SUBJECT: Forwards response to request for addl info re NUREG-0737,
 Item II.B.1, "RCS Vents."

Donald C. Cook Nuclear Plant Unit Nos. 1 and 2
Docket Nos. 50-315 and 50-316
License Nos. DPR-58 and DPR-74
NUREG-0737, ITEM II.B.1, REACTOR COOLANT SYSTEM VENTS
REQUEST FOR ADDITIONAL INFORMATION

ADDITIONAL INFORMATION ON REACTOR COOLANT
SYSTEM VENTS

Figure 1

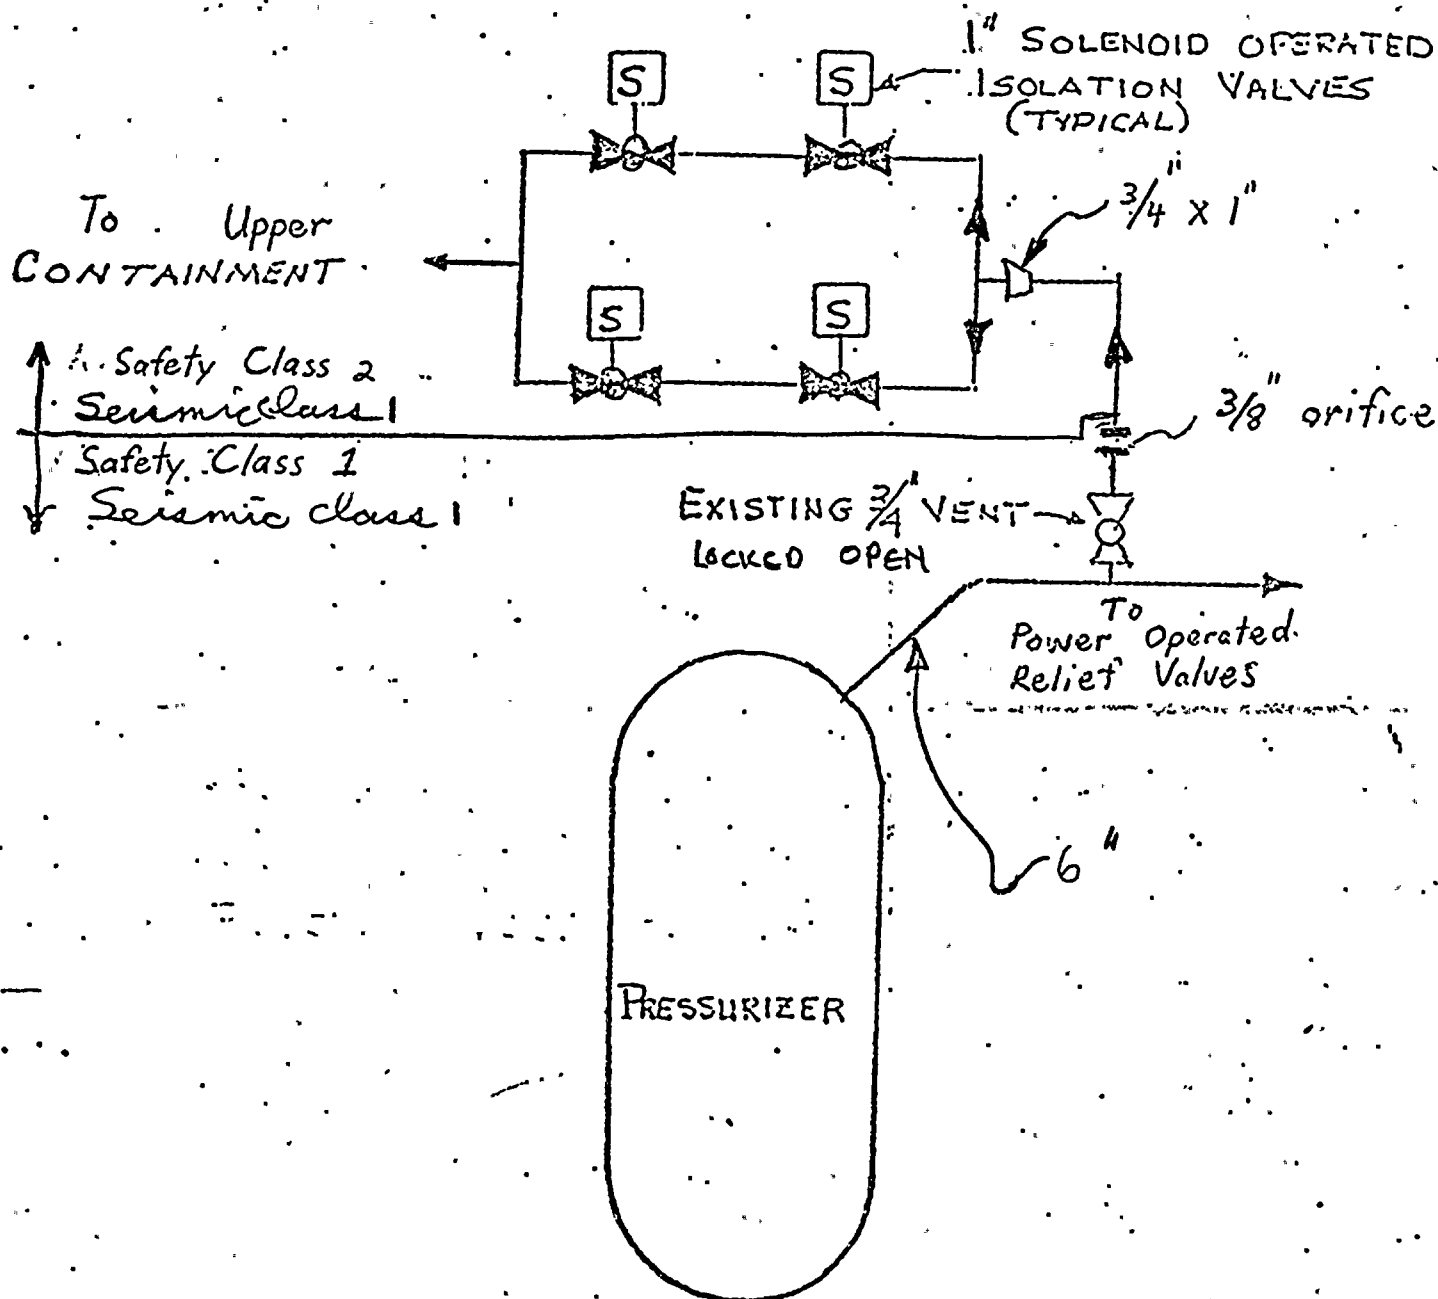
- (a) The entire RCS Vent System is classified as Seismic Class I. Figures 1 and 2 of this Attachment 1 show the location of the second normally closed valve.
- (b) The piping, valves and orifices in the RCS Vent System are designed to 2485 psig at 650°F.
- (c) The following are the materials of construction in the RCS Vent System:

TEST PERFORMANCE CURVE NO.

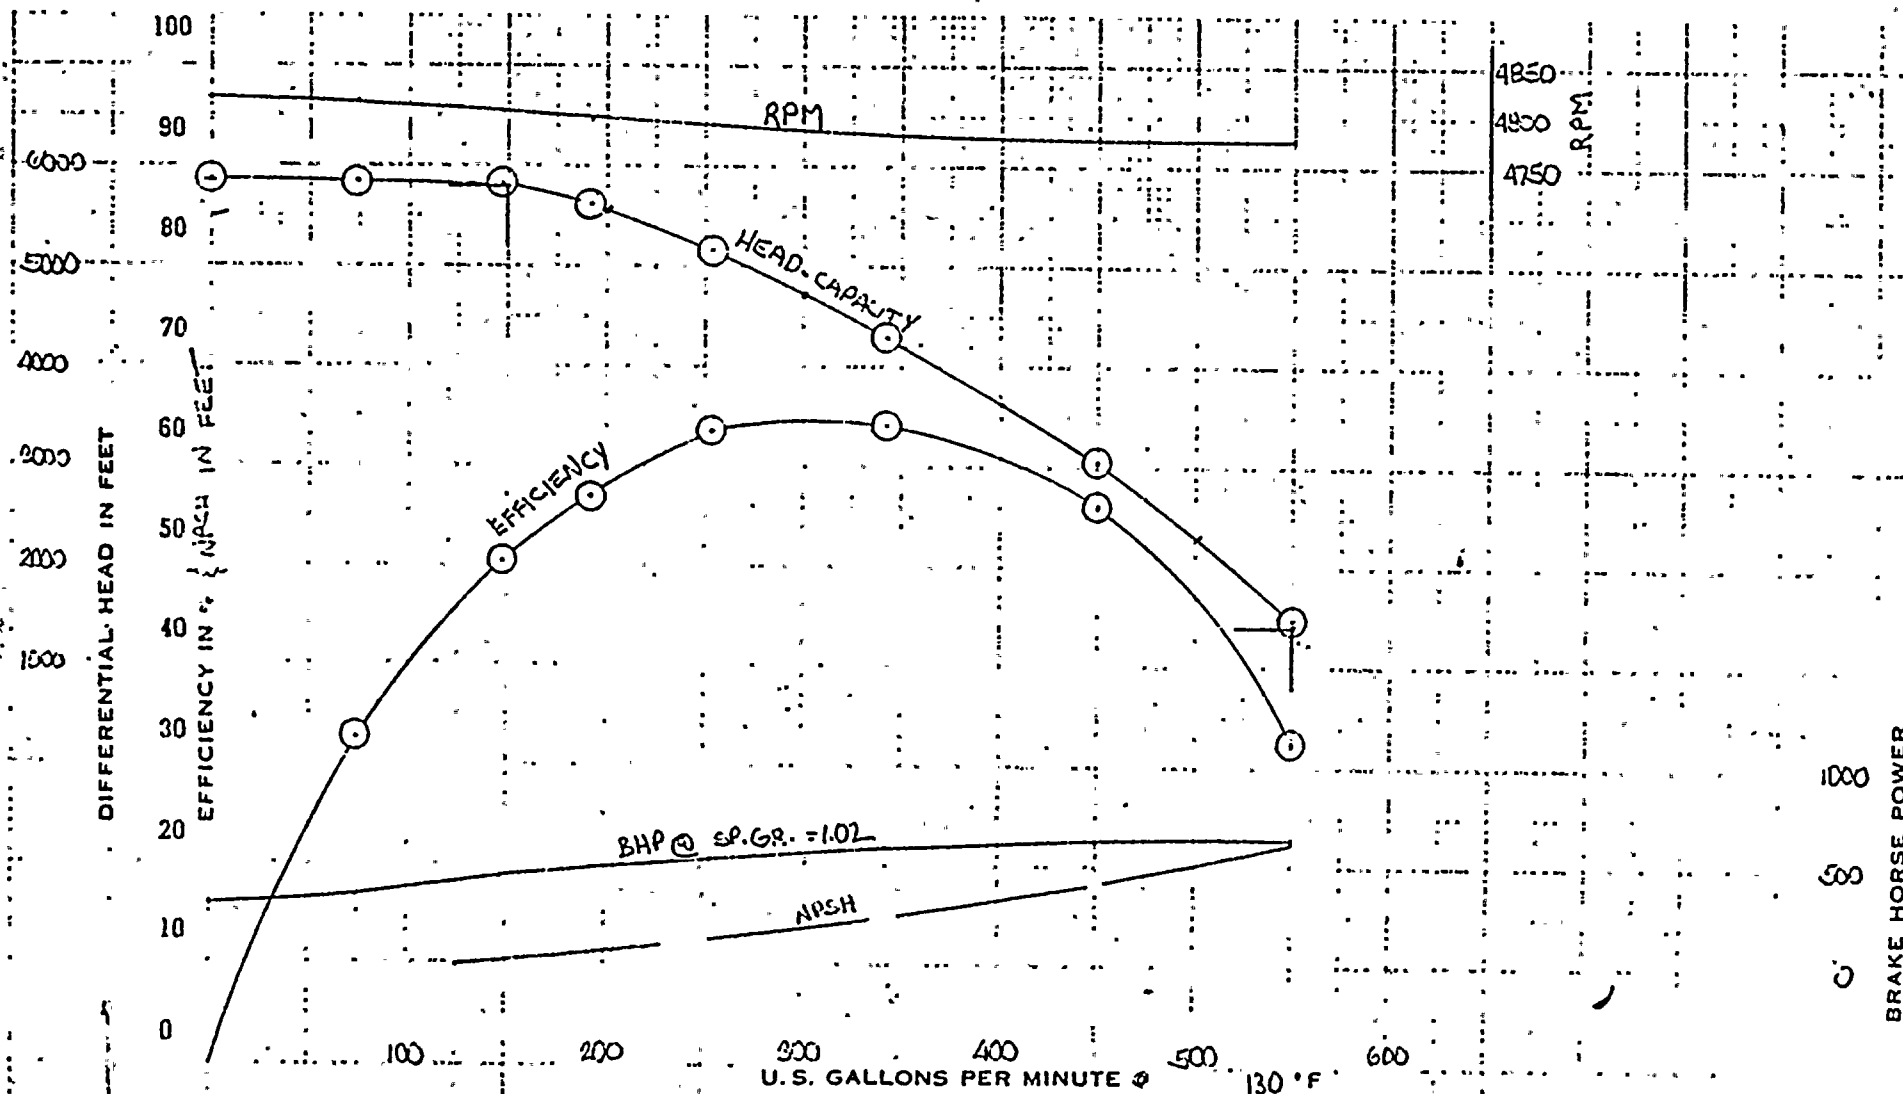
A (3/8) inch diameter flow restriction orifice is provided in both the Reactor Vessel Head Vent and the Pressurizer Head Vent. As the calculation shows in Attachment 2, the maximum postulated flow through each of the orifices is 147.2 gpm. From the centrifugal charging pump flow characteristic curve, also attached, it can be seen that the pump flow is 250 gpm at the system operating pressure (approximately 5200 ft. of water). Thus, enough margin exists between the capacity of one charging pump and the maximum postulated leak rate through one orifice in each vent path.
